6574A-07A

S E R V I C E N O T E

6574A DC POWER SUPPLY MANUALLY CONTROLLED

The Current Shunt (Circuit Reference “R907”) may have intermittent sense wires, which may cause Instability of Current regulation, Current read back and Current programming.

This picture shows how the Shunt R907 is connected using the term-crimp connectors.

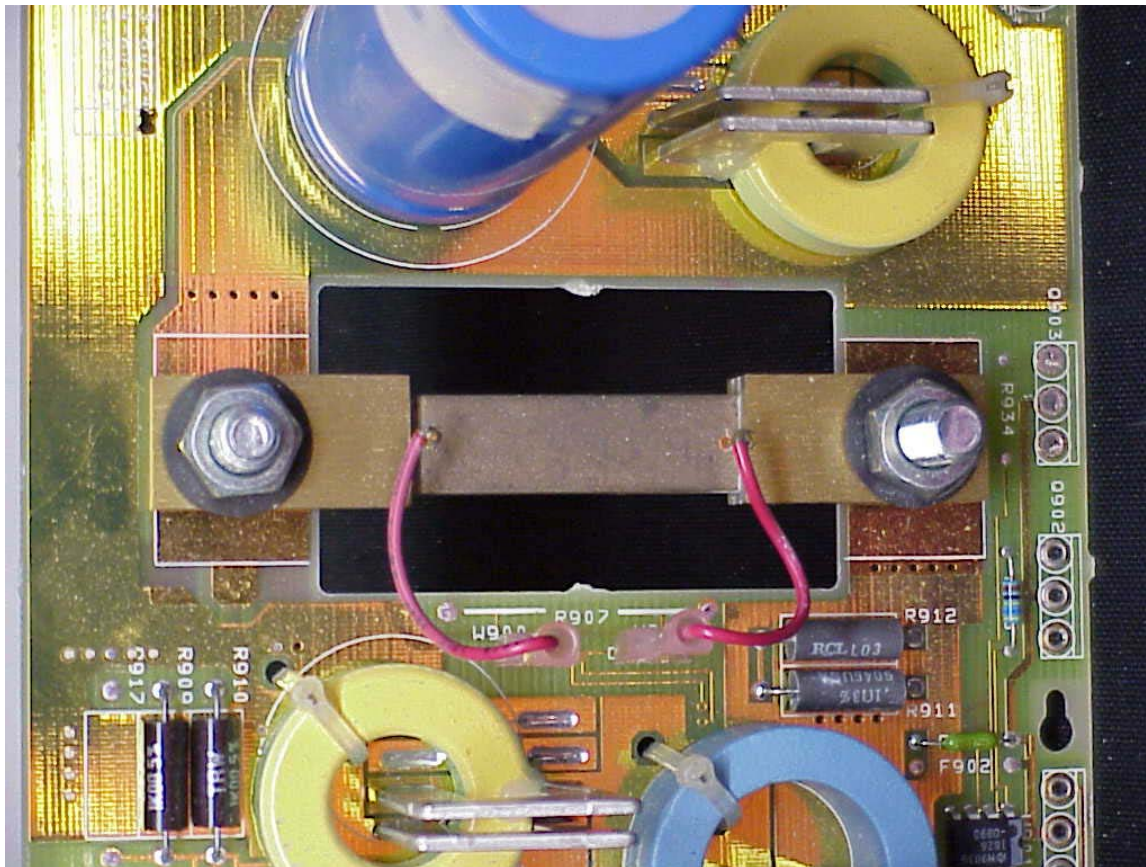
When the push-on connectors become intermittent the output current will become unstable. Loose push-on connectors can cause the output current to change dramatically. The current can change from any set current, and may go to the maximum rated output current of the instrument.

The Shunt R907 is connected to "W900" & "W901"

Cut the terminal-crimp connectors off of both wires and discard the connectors. Make this cut as close to the terminal-crimp connector as possible. The required strip length should be 5mm. This strip length will be used to prevent the wire length being too long and shorting to the instrument chassis. If replacement of this wire is required any color (22 AWG, 300V 105C) wire type can be used.

This modification can be done from the top of the board. Carefully strip and solder the wires, and avoid burning the wire insulation and the printed circuit board.

The wires should be connected as shown below. There are two holes marked R907 that should be used. Do not cross the wires when making this modification. See picture below for details. This picture shows the required modification.
